## ADDENDUM

This addendum replaces page 8 of your  
FNX Component Systems Operation & Installation Manual

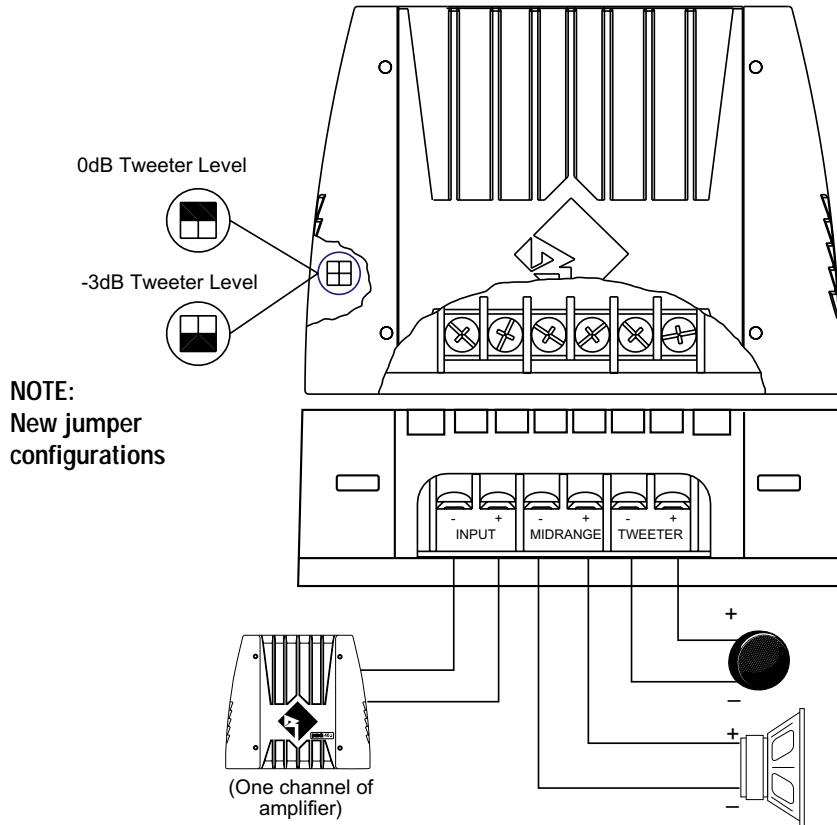
- Be sure to maintain speaker polarity
- 0dB Tweeter Level matches the amplitude of the tweeter to the midrange
- -3dB Tweeter Level reduces the amplitude of the tweeter -3dB lower than the midrange. (ex. Ideal for tweeters located high in door panels and midranges located low in the kick panel.)

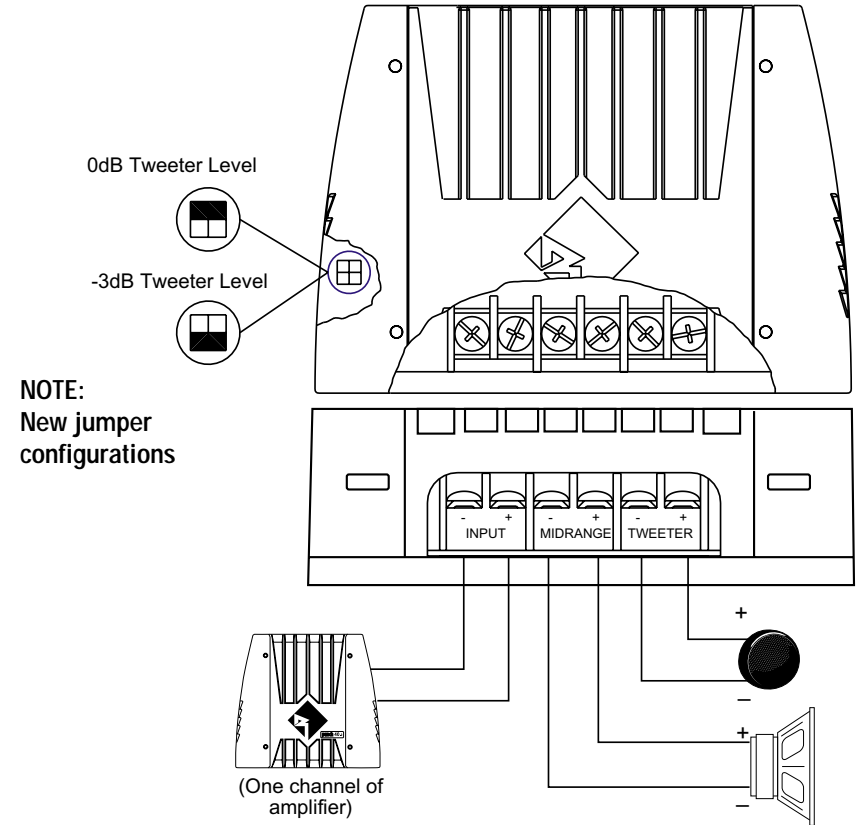
- Be sure to maintain speaker polarity
- 0dB Tweeter Level matches the amplitude of the tweeter to the midrange
- -3dB Tweeter Level reduces the amplitude of the tweeter -3dB lower than the midrange. (ex. Ideal for tweeters located high in door panels and midranges located low in the kick panel.)
